From: Henry Lister <halister@bellsouth.net>
Sent: Wednesday, October 11, 2023 2:58 PM
To: All Agenda Materials <allclerk@townofchapelhill.org>; Town Council <mayorandcouncil@townofchapelhill.org>
Subject: Hillmont materials for Town Council meeting 10/11

Woodmont on NC 54 East Master Land Use Plan

Traffic Concerns Regarding the Hillmont Proposal
Submitted by Henry Lister, supported by residents of Sherwood Forest
October 11, 2023

SUBJECT: Woodmont on NC 54 East Application for Master Land Use Plan
(File No. 9798-04-71-8729)

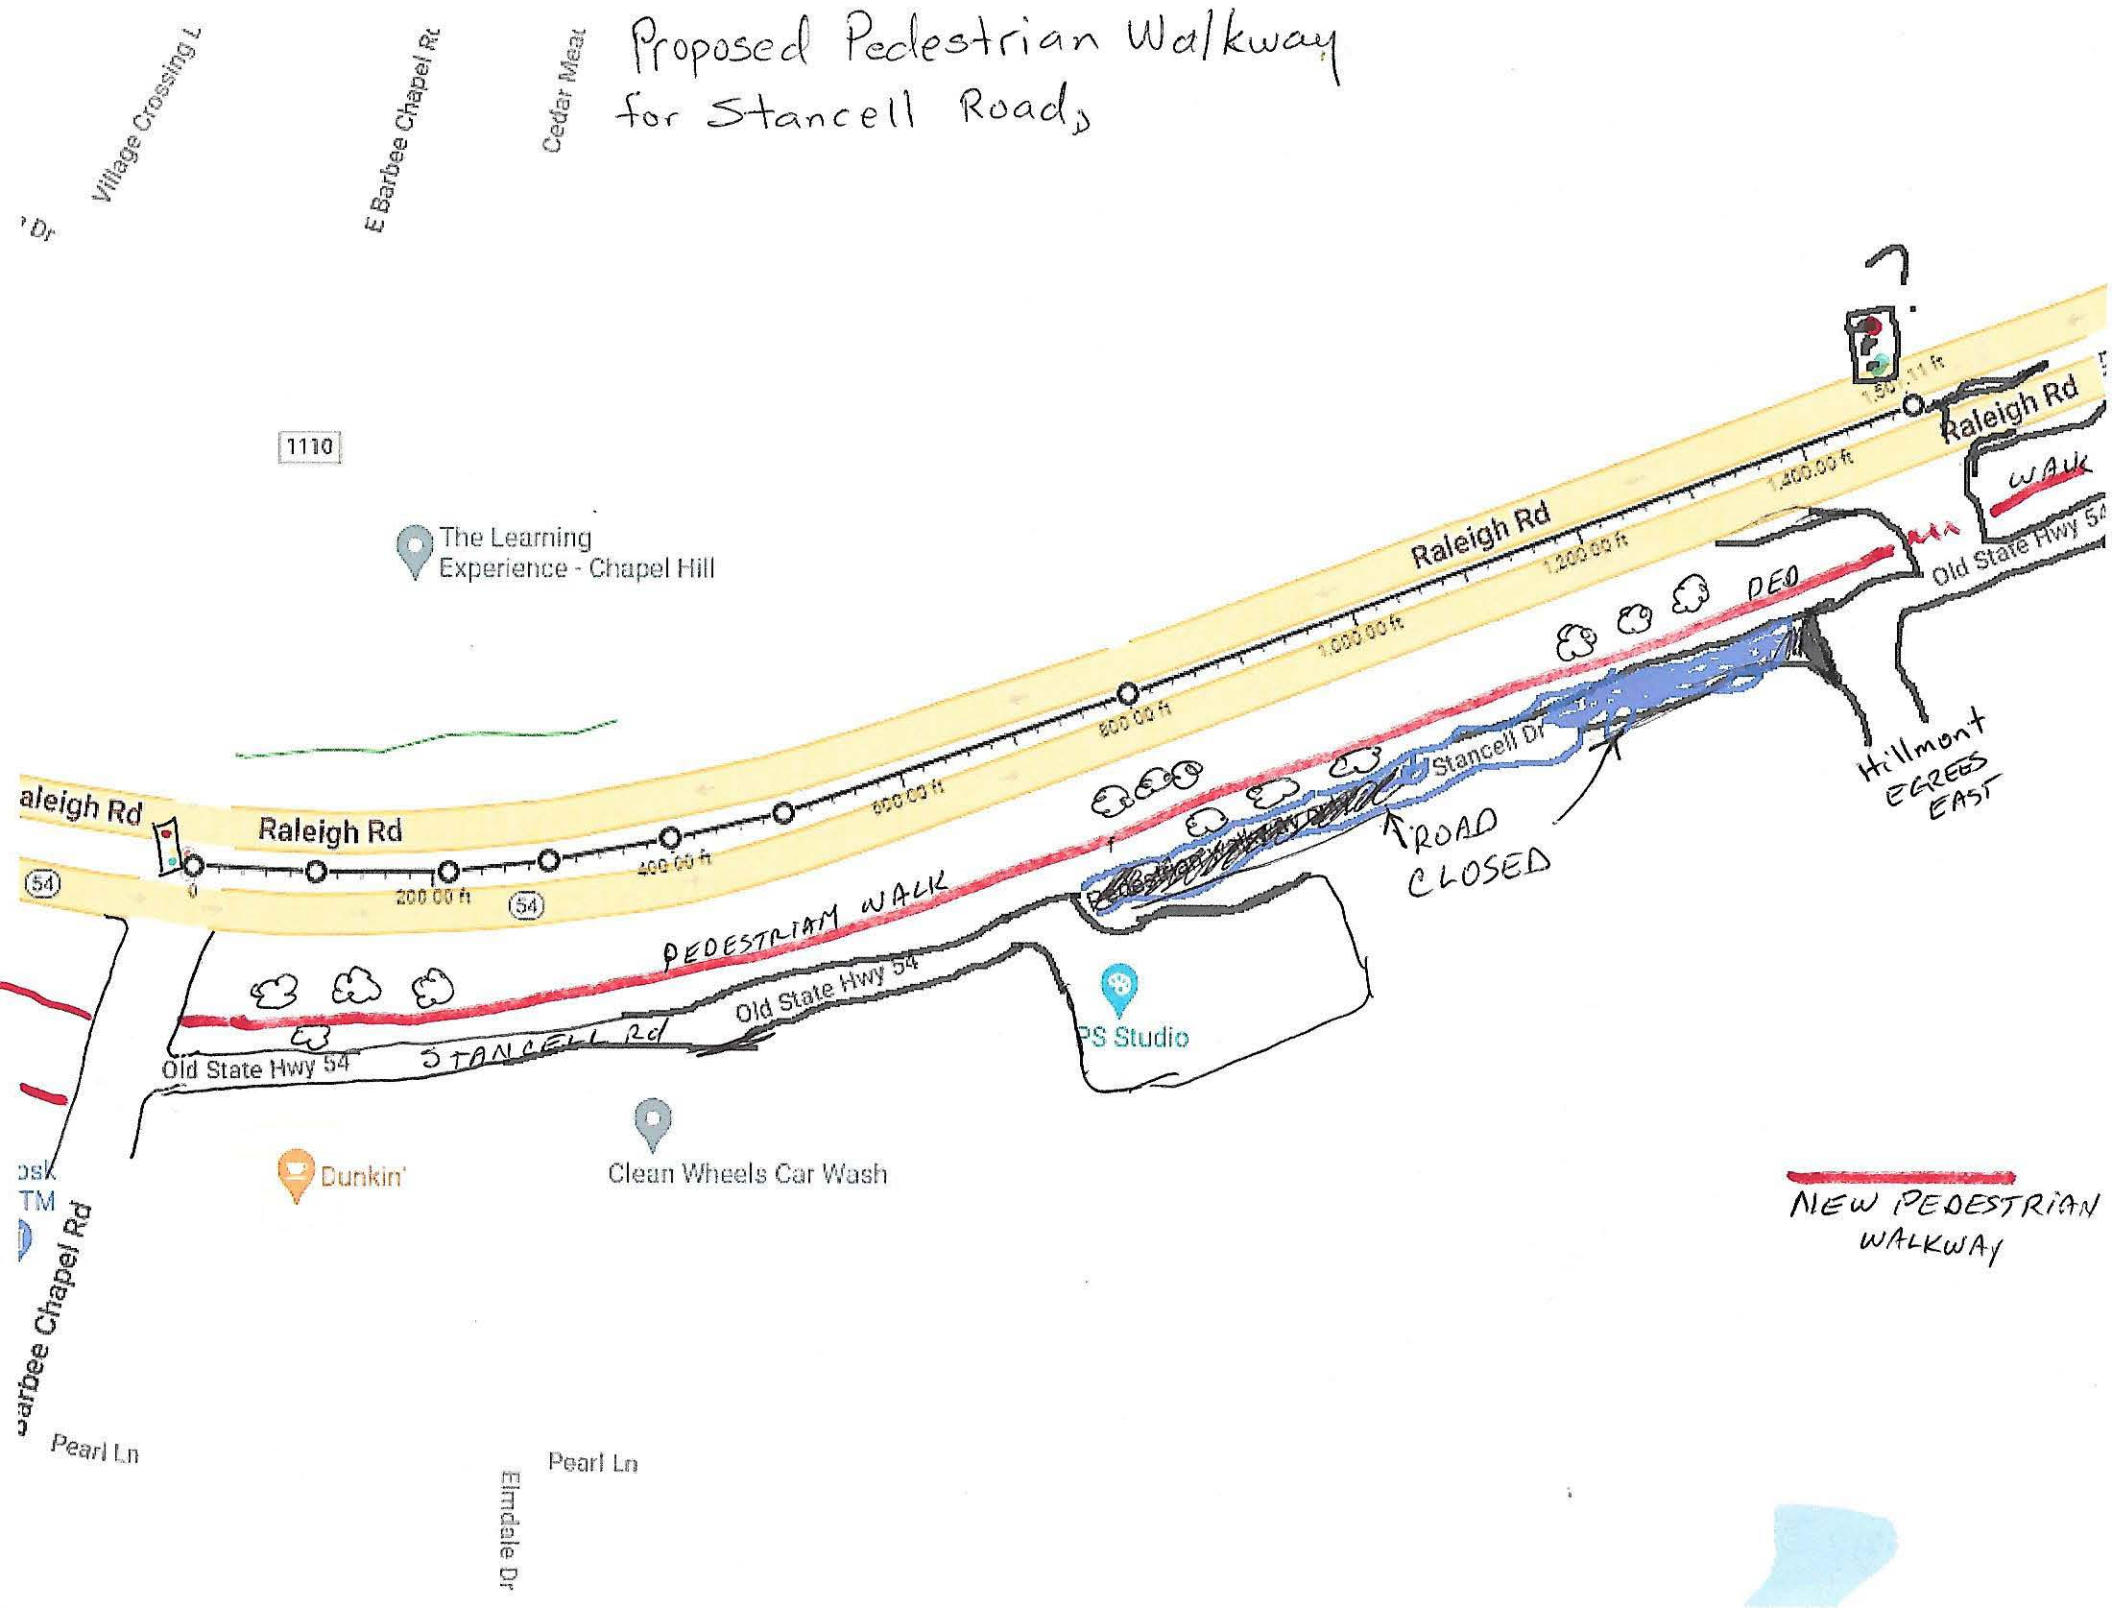
1. Close Stancell Road between the PhotoShop and the east egress proposed by Hillmont. Close Little John Road's access to NC-54, and create a new traffic lighted outlet onto NC-54 to accommodate Sherwood Forest and Hillmont traffic.
2. Create a pedestrian pathway through the verge between NC-54 and Stancell Road extending from Barbee Chapel Road to Downing Creek. This path would be 6-foot wide and landscaped like much of the path adjacent to the 54 East office buildings.

The goal of these recommendations is to mitigate the extensive traffic created by the Hillmont development while creating new pedestrian opportunities. We hope that you appreciate the difficulty any new traffic poses to an already vexing problem in this area that would be exacerbated by Hillmont.

Proposed Pedestrian Walkway for Stancell Roads

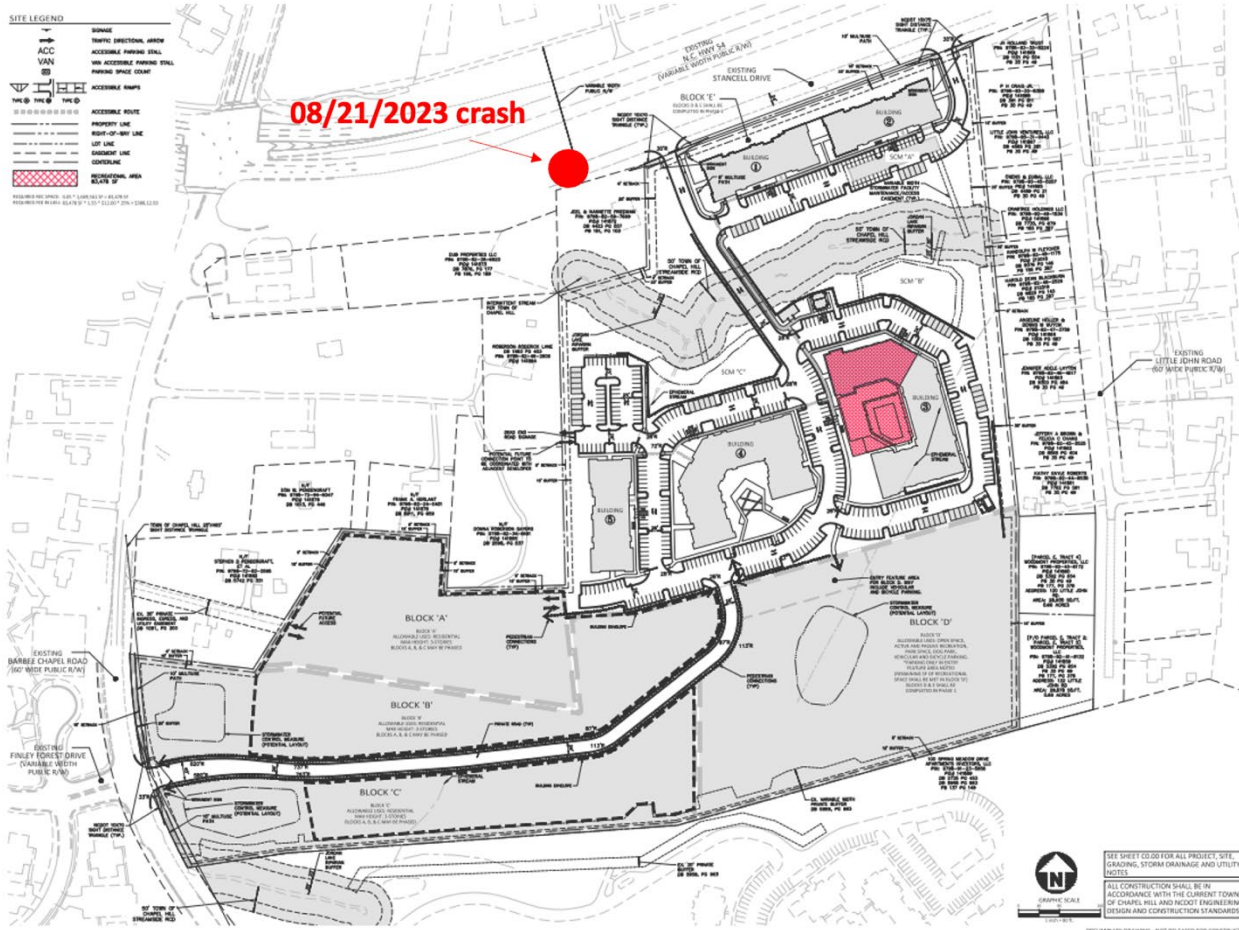
A suitable solution is to extend a path in the verge between NC54 and Stancell Road. This pathway could be landscaped and provide a much needed and safer pedestrian walkway to Downing Creek and Sherwood Forest. (See handout drawing, "Proposed Pedestrian Walkway for Stancell Road").
